SUBJECT: COMANCHE PEAK STEAM ELECTRIC STATION (CPSES)  
DOCKET NOS. 50-446  
TRANSMITTAL OF INSERVICE INSPECTION PROGRAM PLAN  
INTERIM CHANGE REQUEST  
(UNIT 2: 1986 EDITION OF ASME CODE SECTION XI, NO ADDENDA,  
INTERVAL START DATE - AUGUST 3, 1993, FIRST INTERVAL)

Interim Change Request No. ISI-2R0-006

INTERIM CHANGE REQUEST

Plan Title/Rev. Unit 2 ASME Section II Inservice Inspection Program Plan 10 ICR No. 6

**ANSTEC  
APERTURE  
CARD**

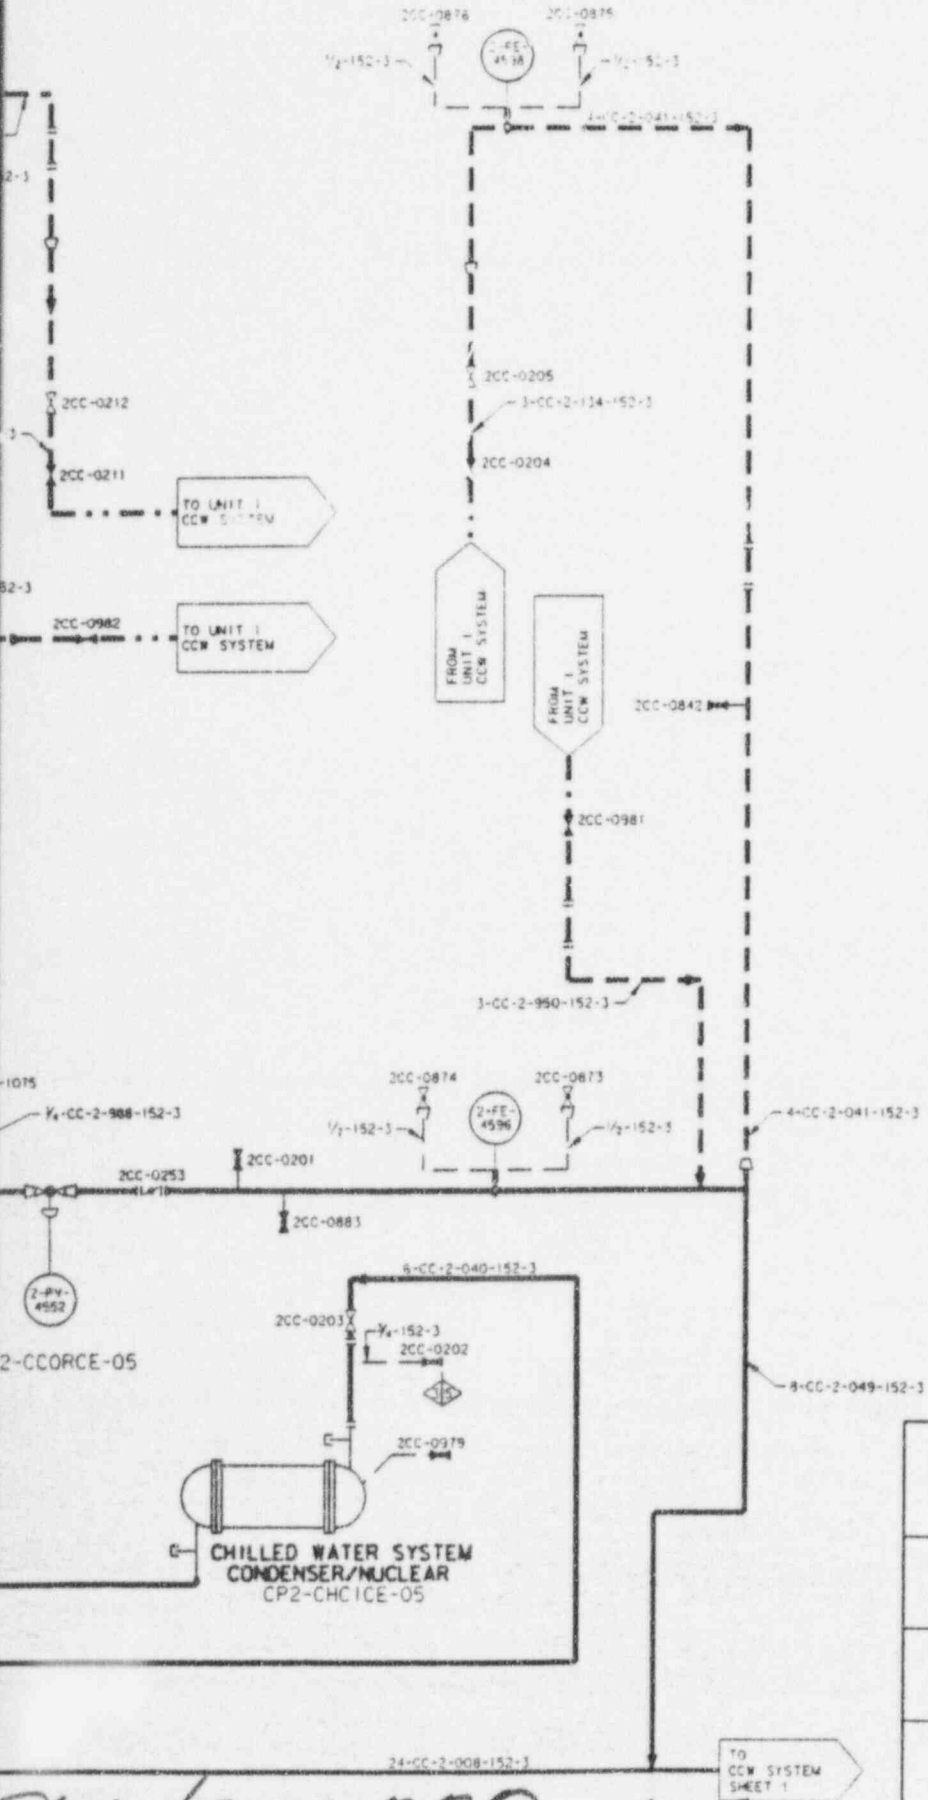
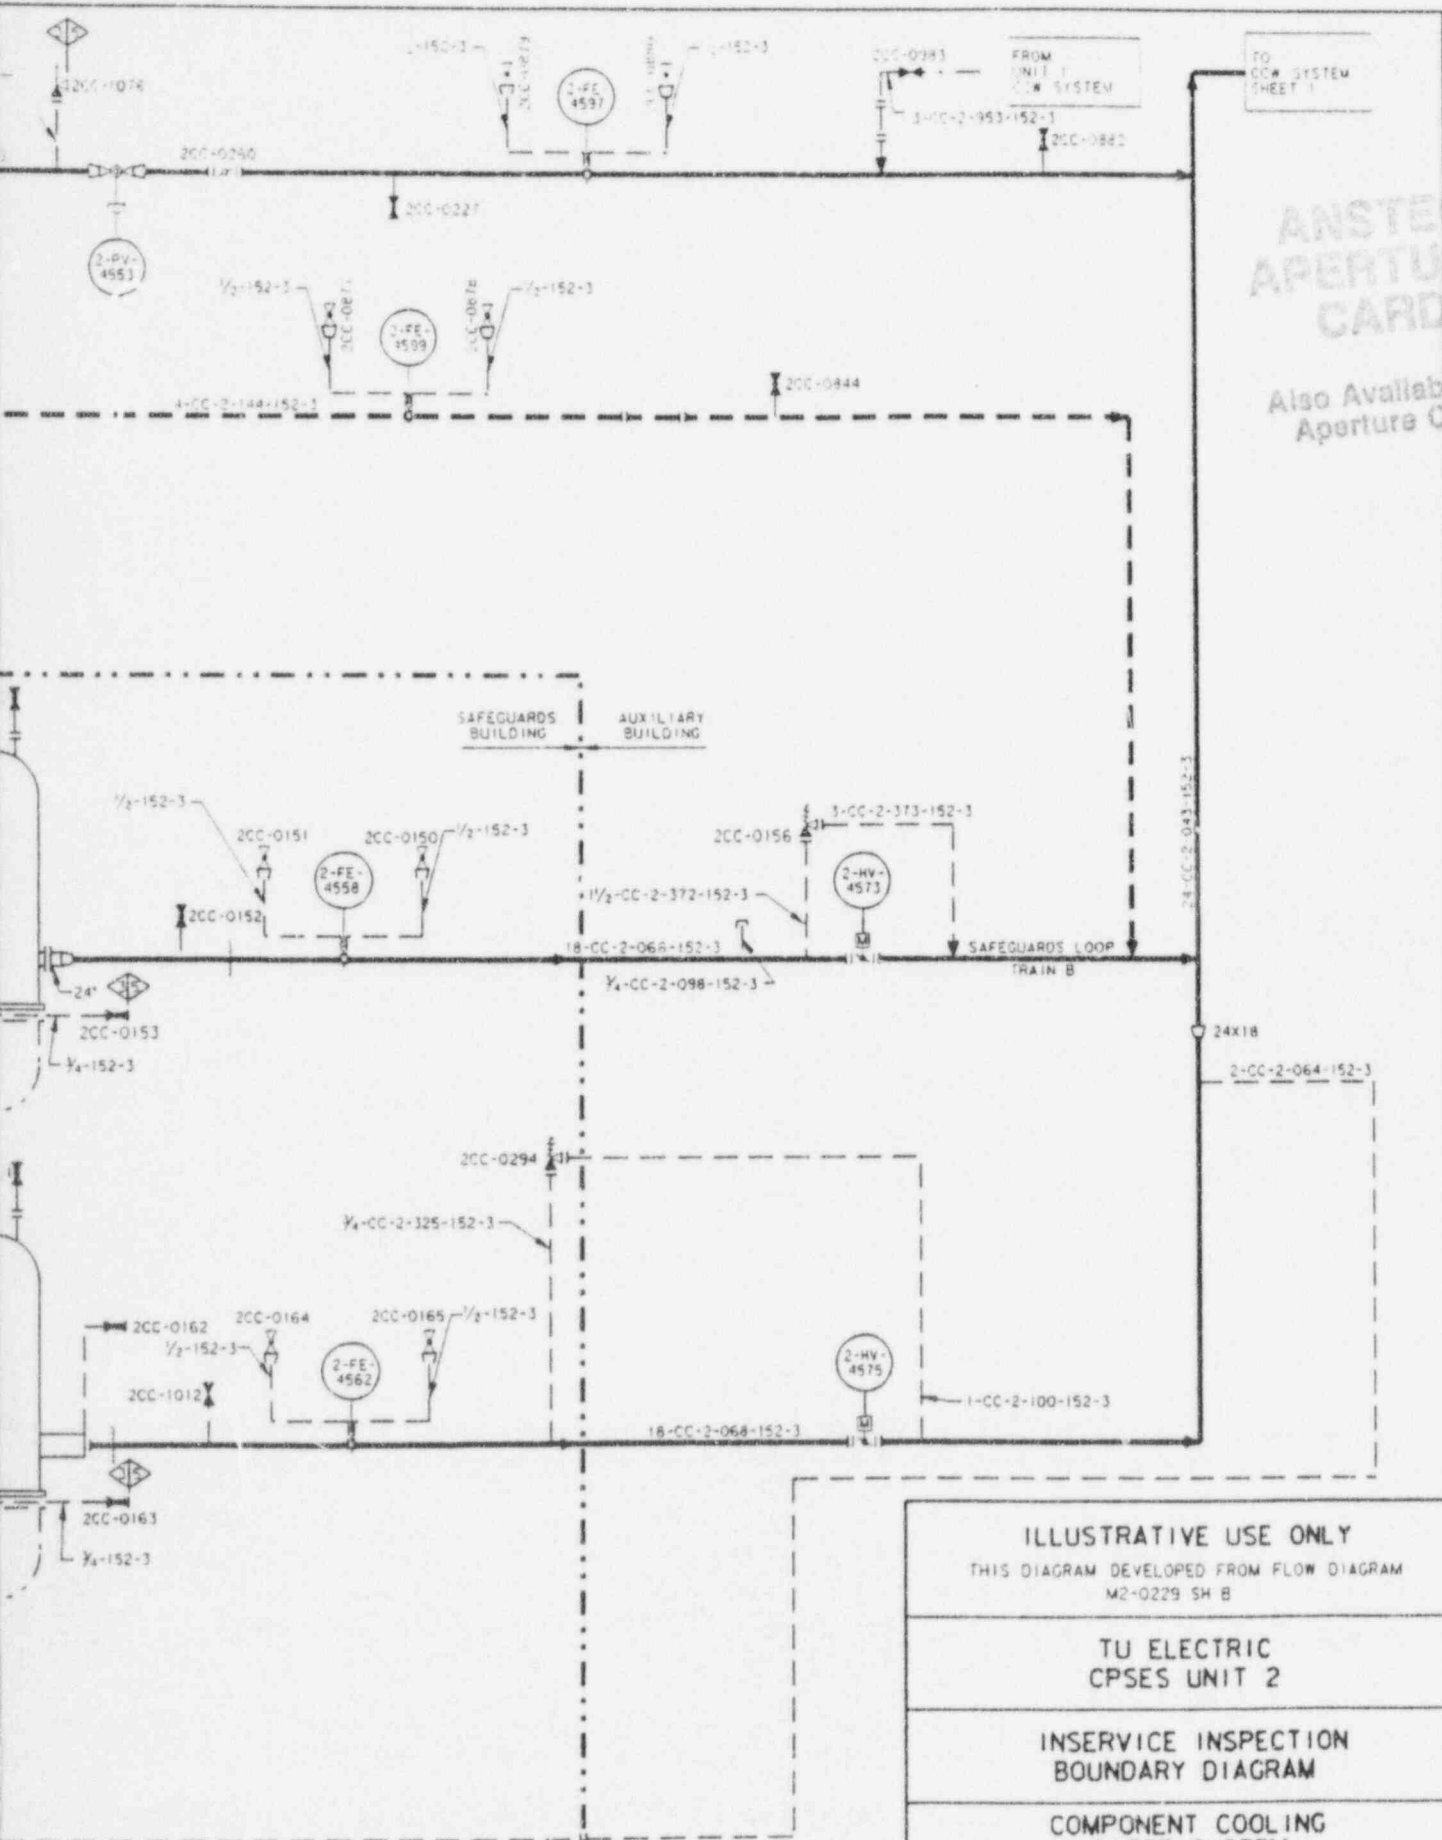
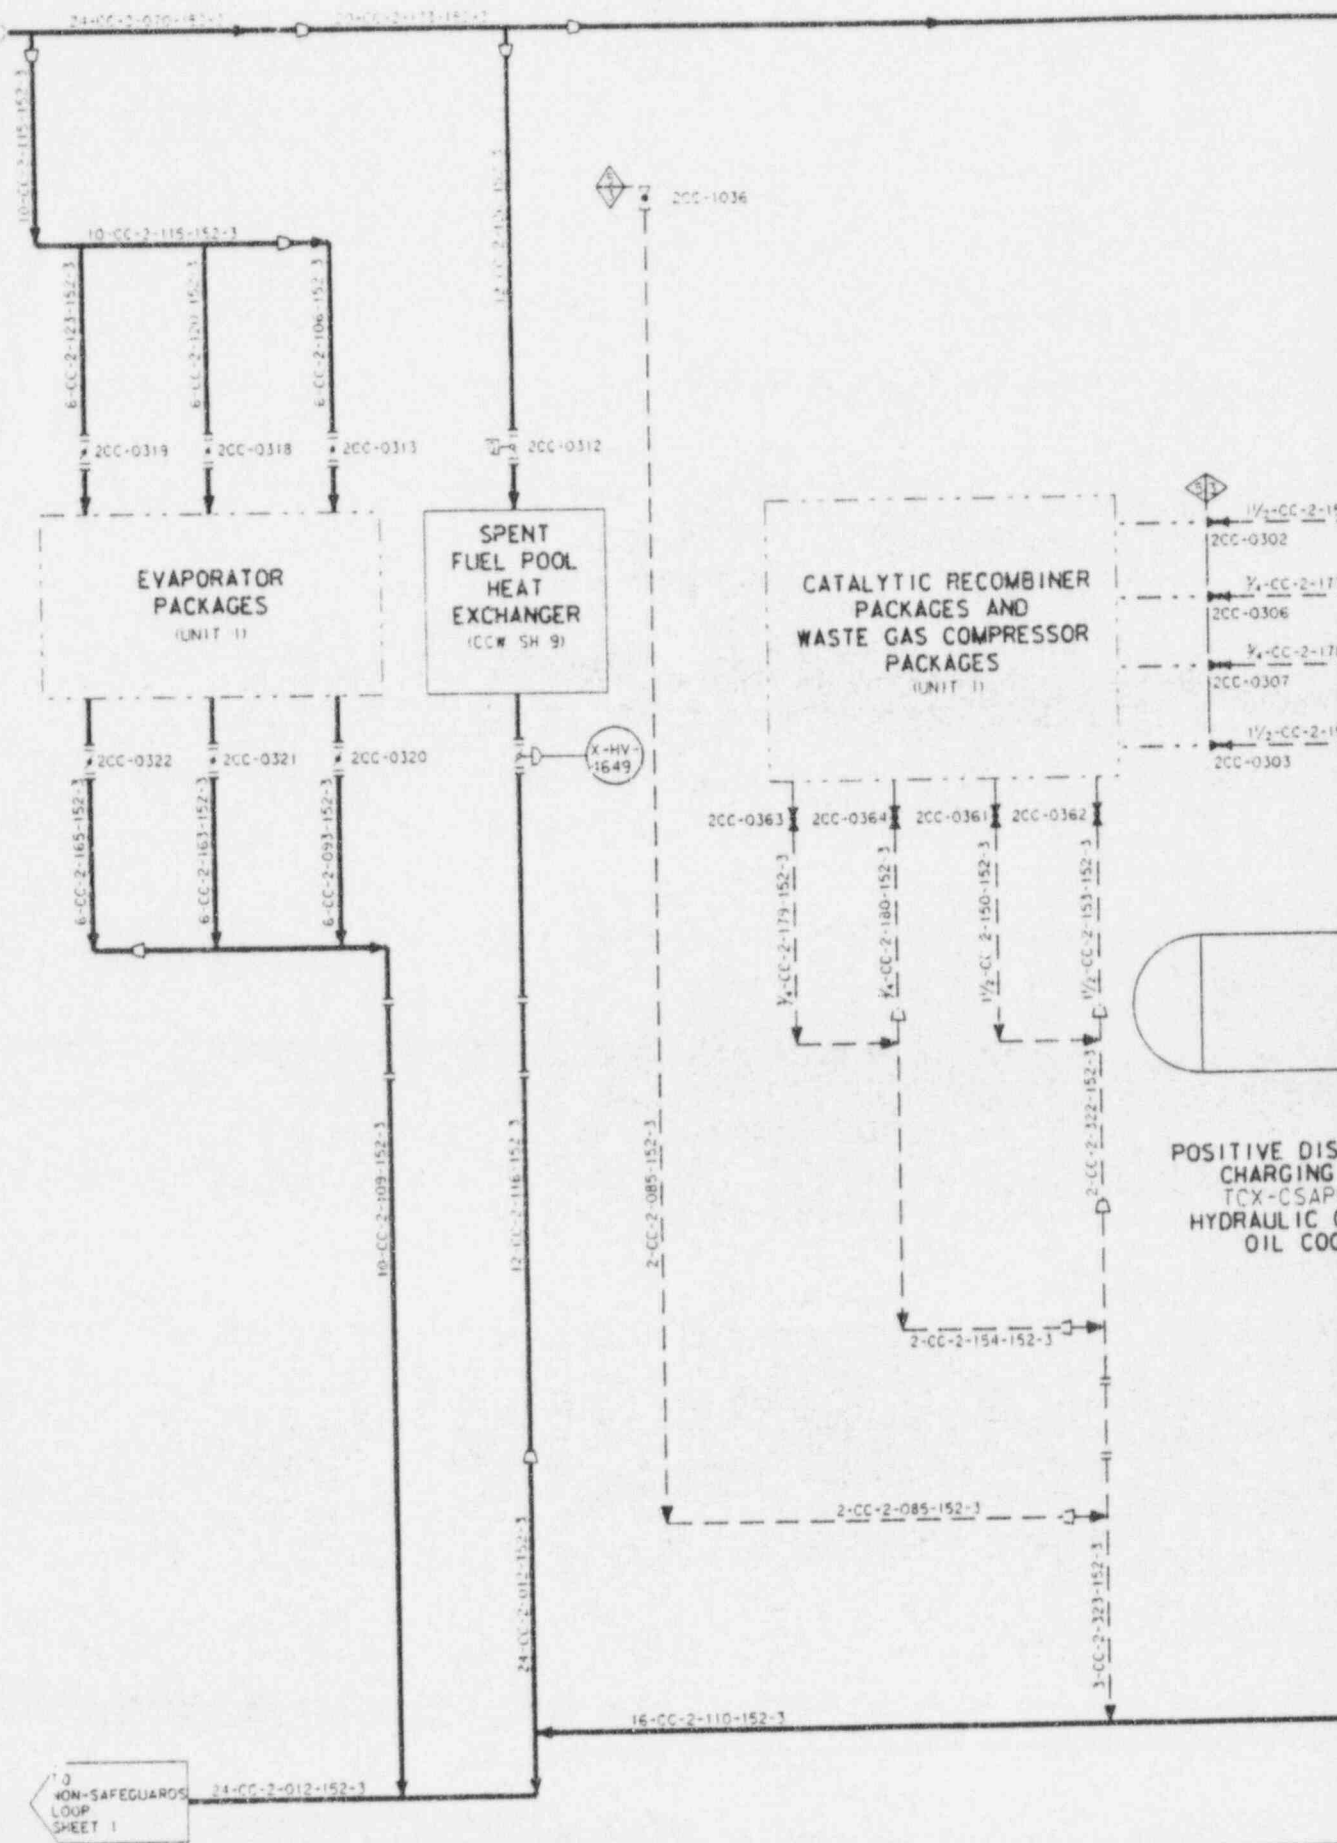
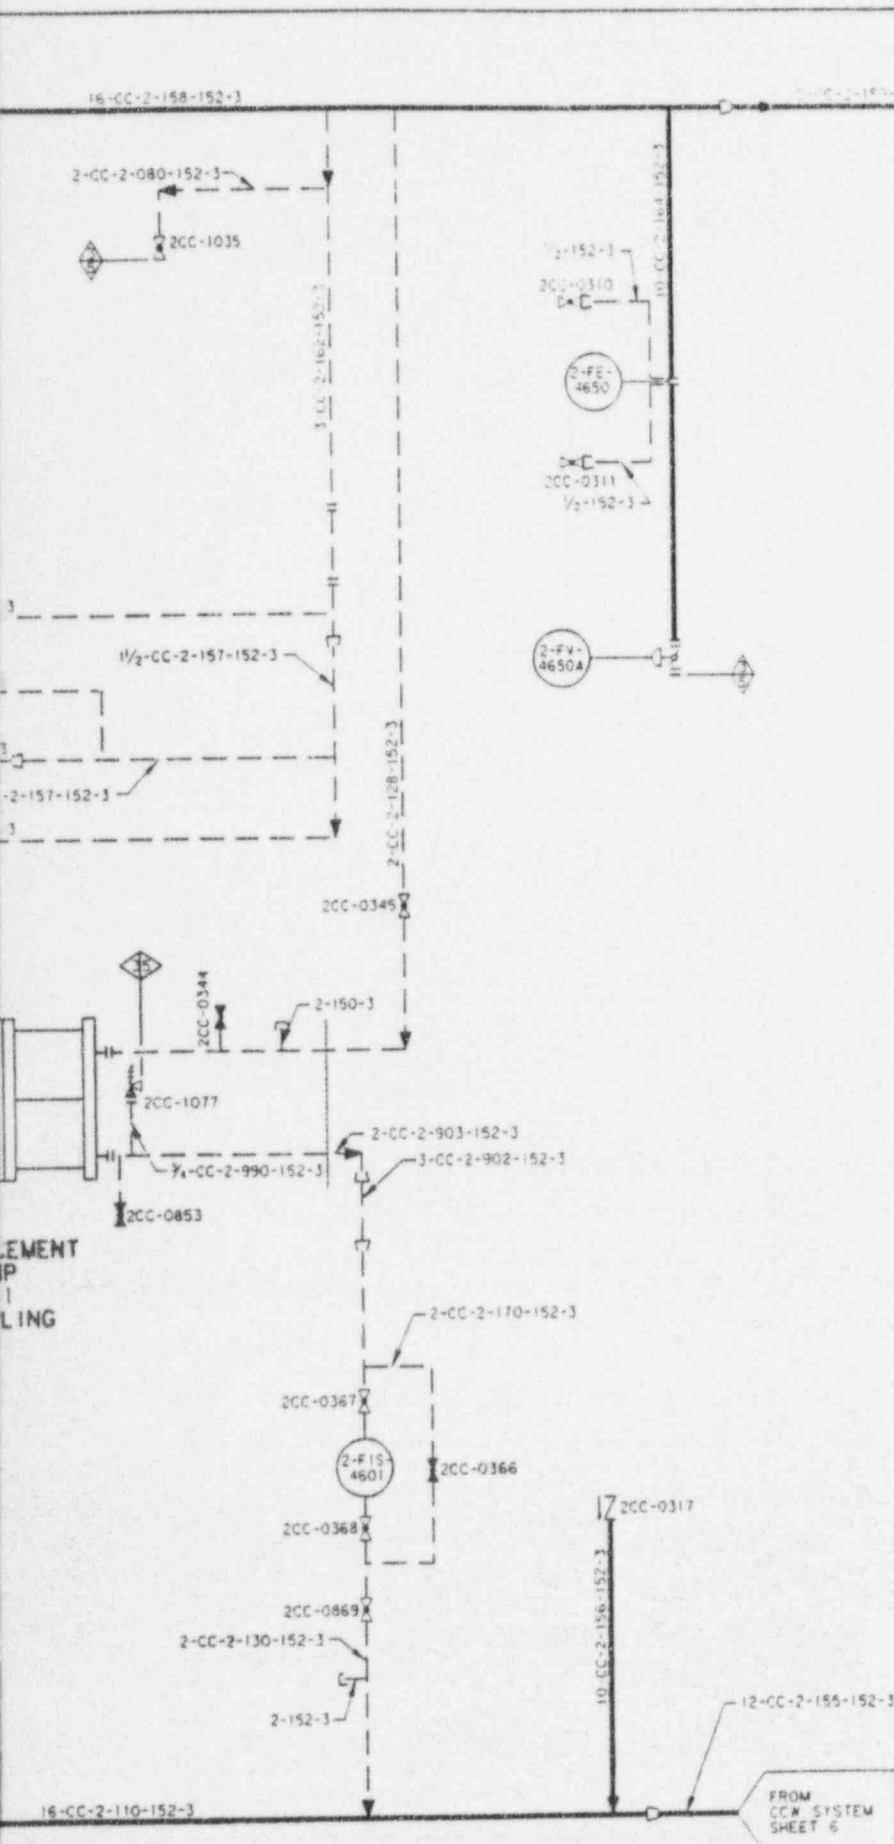
1. CC - Three 24" crossties are provided between Units 1 and 2. Each crosstie is between locked closed butterfly valves. As described in DBD-ME-229, these crossties are not required for any design base accident or safe shutdown. Therefore they do not meet any of the criteria established in Table D-A, D-B or D-C.

The portion of CC which is between containment isolation valves 2-HV-4711 and 2-HV-4710 (both ORC) supplies flow to the shell side of the Reactor Coolant Drain Tank Hx and the Excess Letdown Hx. The Excess Letdown Hx accommodates expansion related flow in excess of the capabilities of normal CVCS letdown during plant heatup. The Reactor Coolant Drain Tank is part of the Waste Processing (WP) system. As described in DBD-ME-264, "Liquid Waste Processing System", the WP system does not perform a safety function. Valves 2-HV-4710/4711 close upon an S-signal. Therefore, the requirements of Category C-H note (7) are met.

Replace Table 9 of Section 5.0 with the attached. Replace the existing drawing with the attached drawings as listed below. A detailed justification of this change is attached.
